(C844XD110) (K020)
 CS CA 3920 (H188)(J378) 1 DF 3 C. L. R. R.
 2009\CA\CDMEVELEC\CS\3920
 12V WIRING DIAGRAM 10/17/07 10/25/07

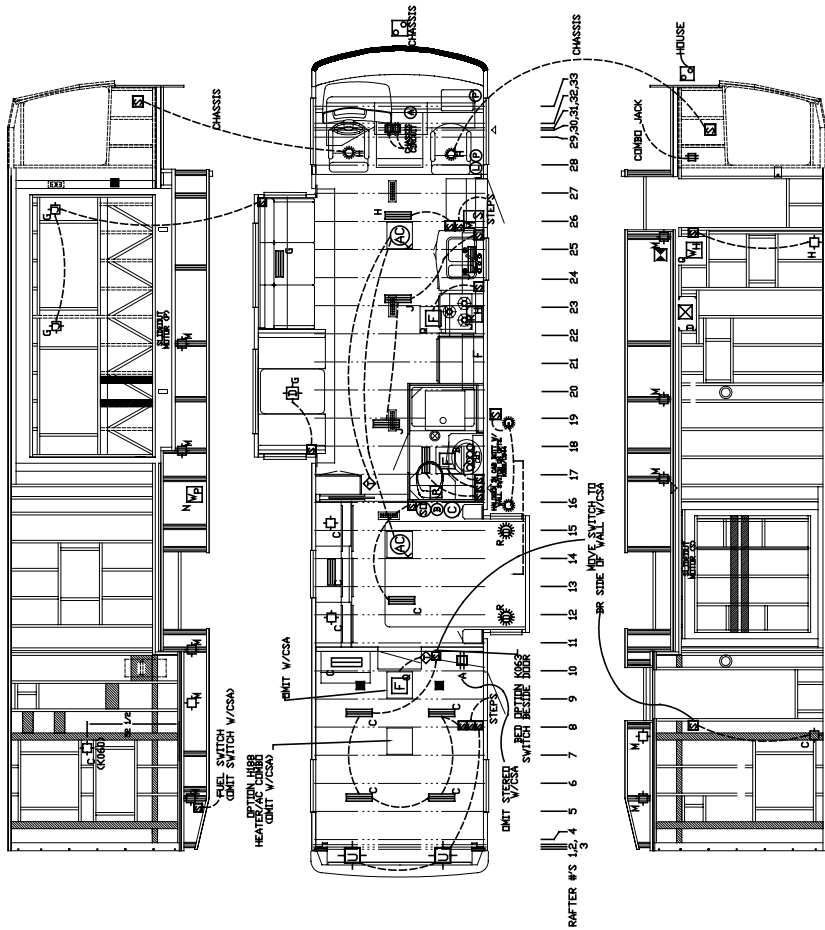
WALL MOUNTED READING LIGHT LOCATED ON FRONT DS AND DDS SIDEWALL REMOVED AND R. R.
 REPLACED WITH A CEILING MOUNTED HALOGEN LIGHT ABOVE DRIVER AND PASSENGER SEAT PER ECO #202 6/3/08
 REVISED FUEL PUMP SWITCH & LIGHT LOCATIONS IN REAR CARGO AREAS R. R.
 (PCR #72494) 5/29/08 R. R.
 CENTER DINETTE LIGHT ON TABLE, DELETE HALOGEN (ECO #363) 5/28/08 R. R.
 ADD OPTION C844 (ECO #310) 5/23/08 R. R.
 FLOURESCENT ILD INCANDESCENT (ECO #43), HALOGEN ILD DIRECTIONAL R. R.
 W/ OPT. K020 (ECO #24) 3/20/08 C. L.
 REVISED TO REFLECT WALK-THRU CHANGES, ADDED CSA INFORMATION (ECO #K9) 2/18/08 C. L.
 REVISED BR CAB LIGHTING (ECO #674) (ECO #383) 2/7/08 R. R.
 MOVE THERMOSTAT AWAY FROM DOOR TO DRY BAR SIDE R. R.
